Addendum #1

**General Contractor for Retaining Wall Reconstruction at ÉC
Monseigneur-Jamot, Peterborough**

Re: ÉÉC Monseigneur-Jamot (Job No. 2021-024)

Revisions to Drawing Set

PROJECT:		PROJEC ÉEC Monseigneur-Jamot 2350 WOODGLADE BLVD PETERBOROUGH, ON K9K 2J6	
DRAWING:			
SEDIMENT CONTROL PLAN			
DRAWN BY:	KMR	SCALE:	1:250
CHECKED BY:	TM	DATE:	2021-05-05
JOB NO.:	2021-024		L-ESC DRAWING 4 of 8
File #2021-024

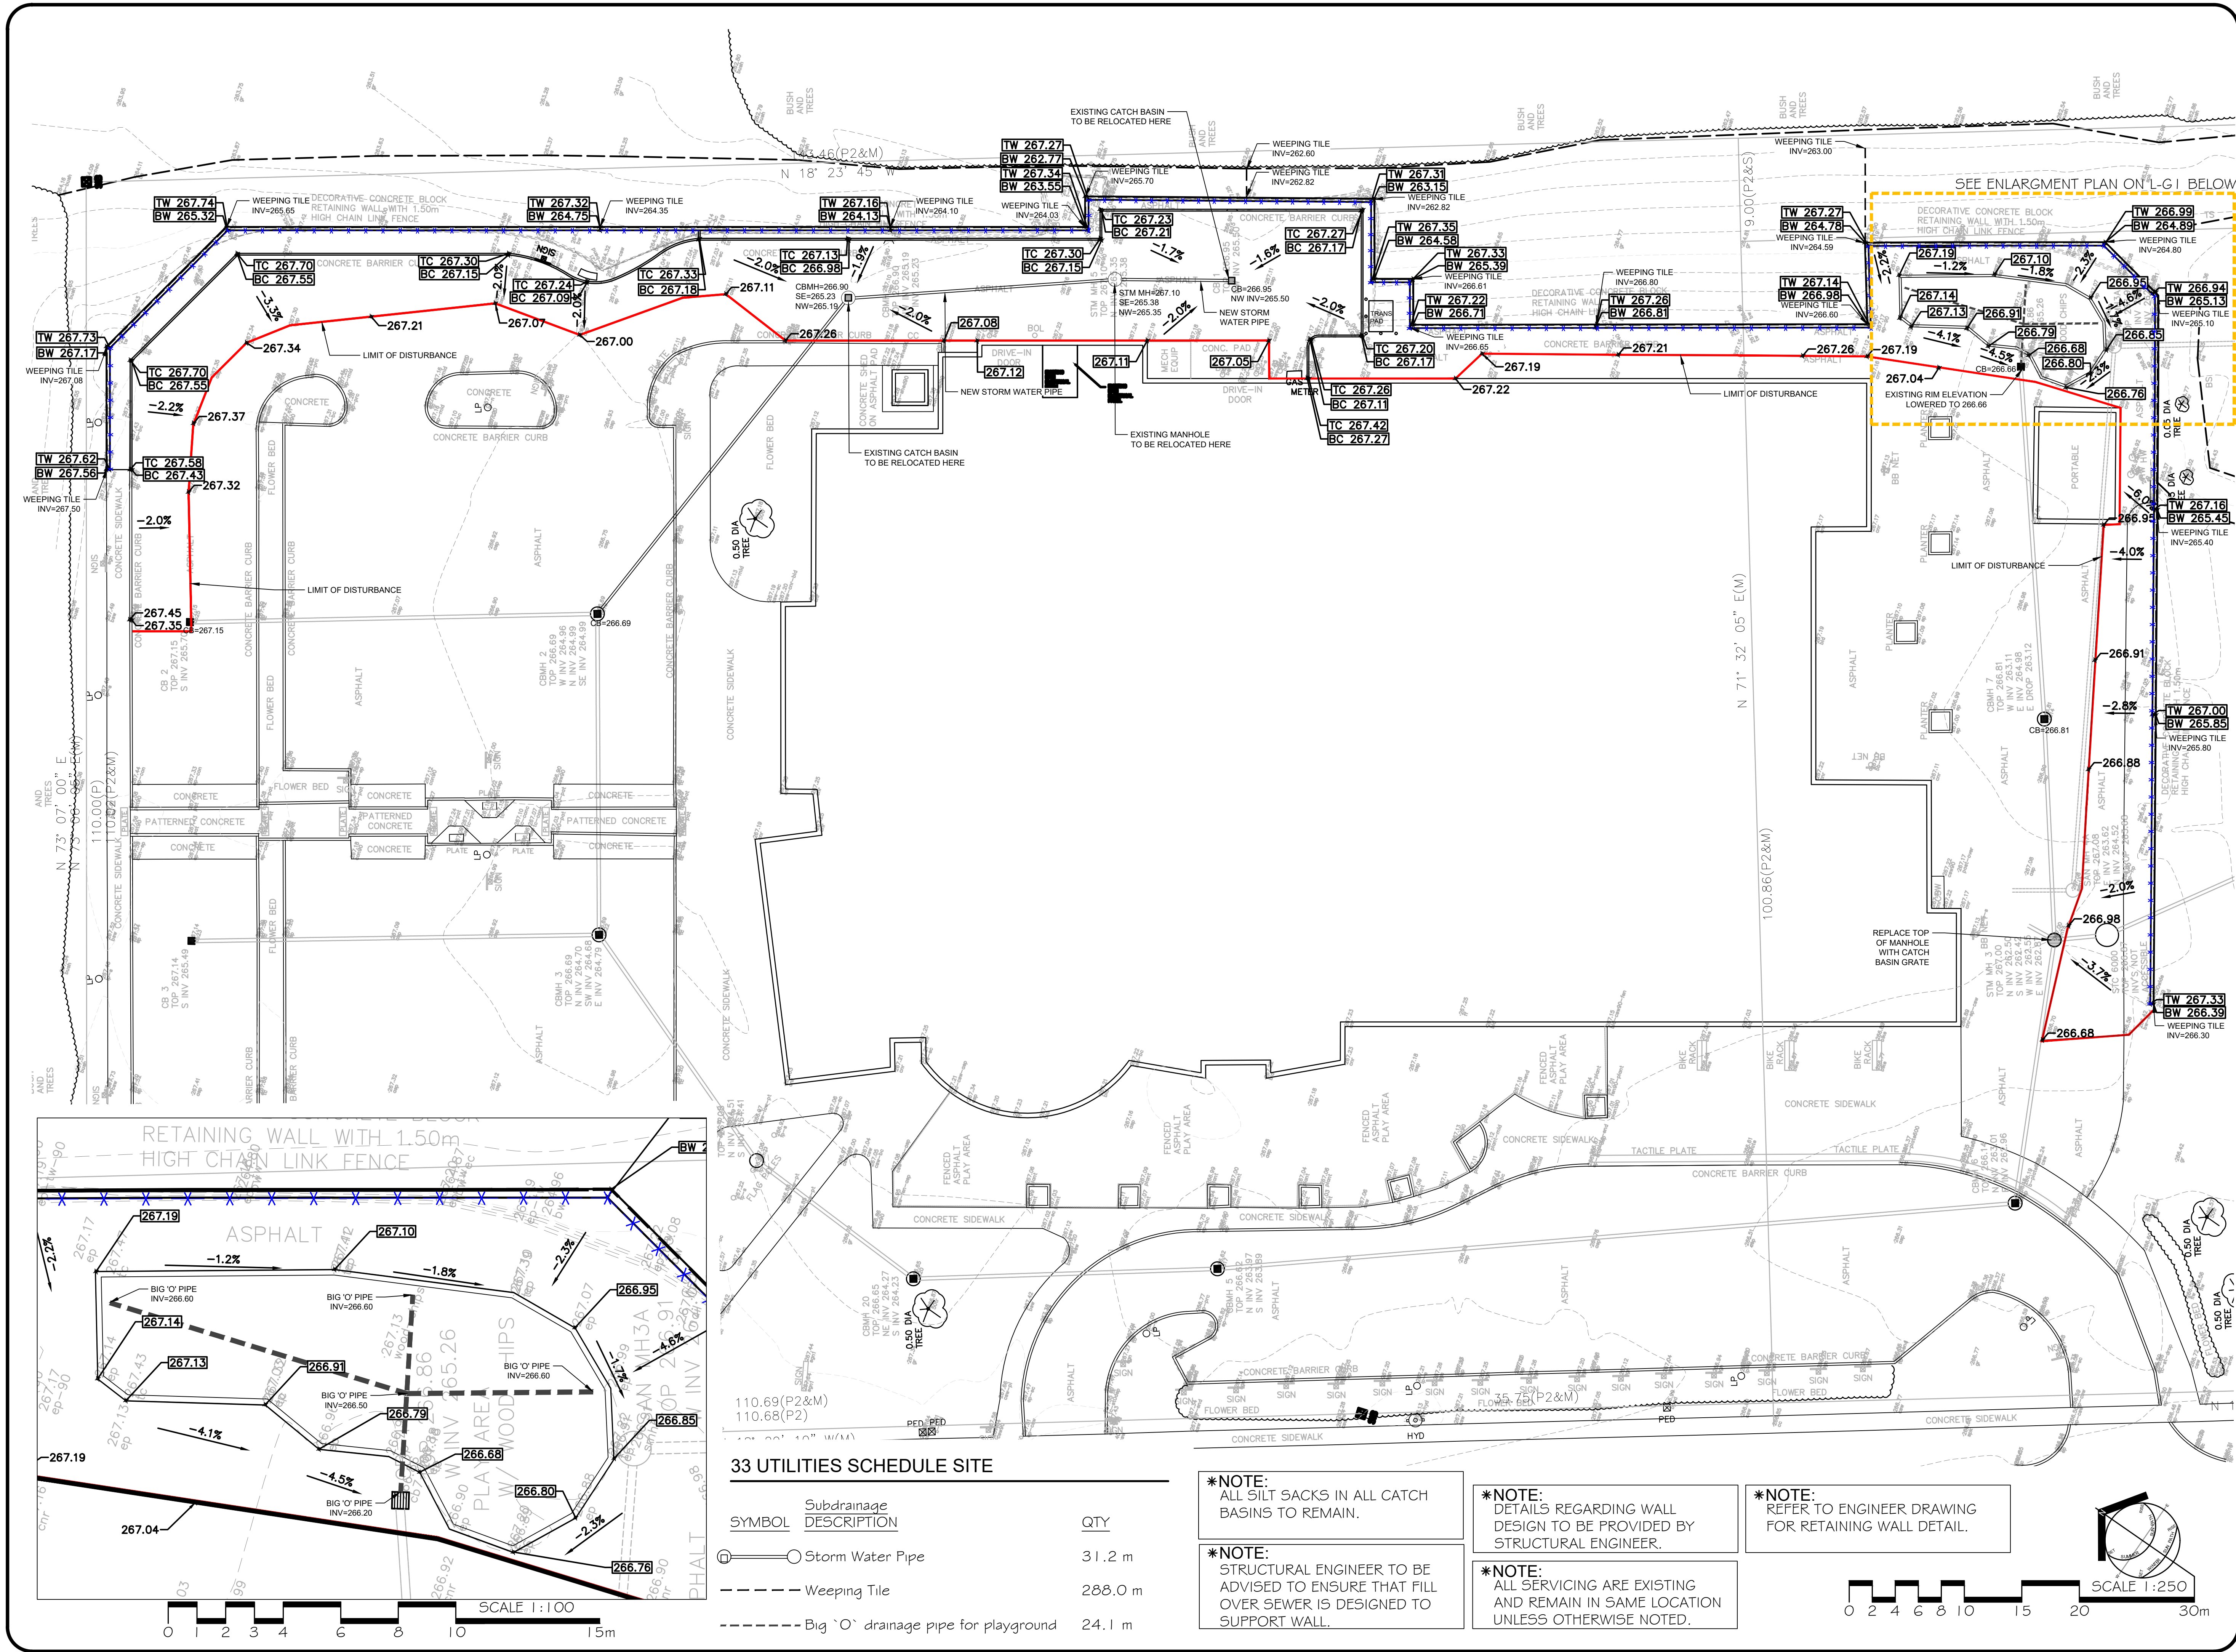
- 1.1 Silt fence has been replaced with heavy duty silt fence and detail has been revised (L-ESC1, 5/L-D1).
- 1.2 Temporary safety fence has been extended along the school (L-ESC1).
- 1.3 Identified location of access to construction zone (L-ESC1)
- 1.4 Top and bottom of curb elevation near the sanitary sewer/catch basin has been lowered (L-G1).
- 1.5 Elevation around playground has been revised (L-G1)
- 1.6 Rim elevation of catch basin near play area has been lowered.
- 1.7 Original Survey by Beninger Surveying Ltd has been included (L-SUR1).
- 1.8 Adjusted transformer location (L-L1).
- 1.9 Five bollards around transformer has been added and included in detail page (13/L-D1).
- 1.10 Typical sign installation detail has been included in detail page (1/L-D2).
